SERVICE BULLETIN

Classification: EC96-009	Reference: NTB96-068	Date: July 31, 1996
-----------------------------	-------------------------	------------------------

1995 MAXIMA SPARK KNOCK

APPLIED VEHICLE: 1995 Maxima (A32) with automatic transmission
Federal emissions only

Figure 1

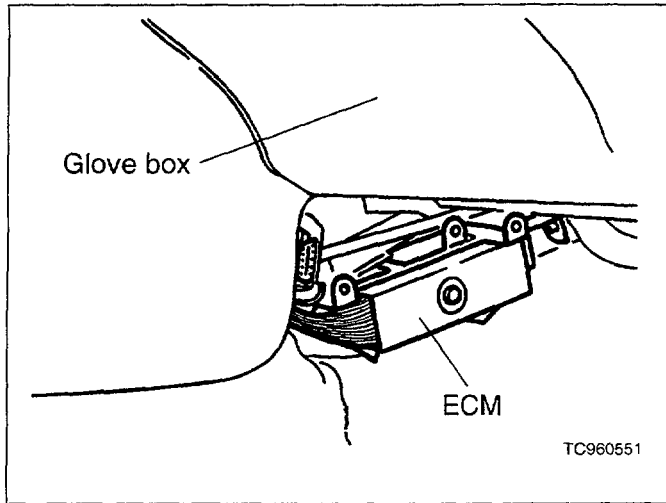
3. If the customer is using premium unleaded gasoline and the EGR system is operating normally, replace the ECM (see Figure 1) with the appropriate countermeasure part listed in the Parts Information table on page 2.
Before replacing the ECM, see steps 1 through 4 of the PRECAUTIONS AND PREPARATION section, page EC-5 of the service manual.
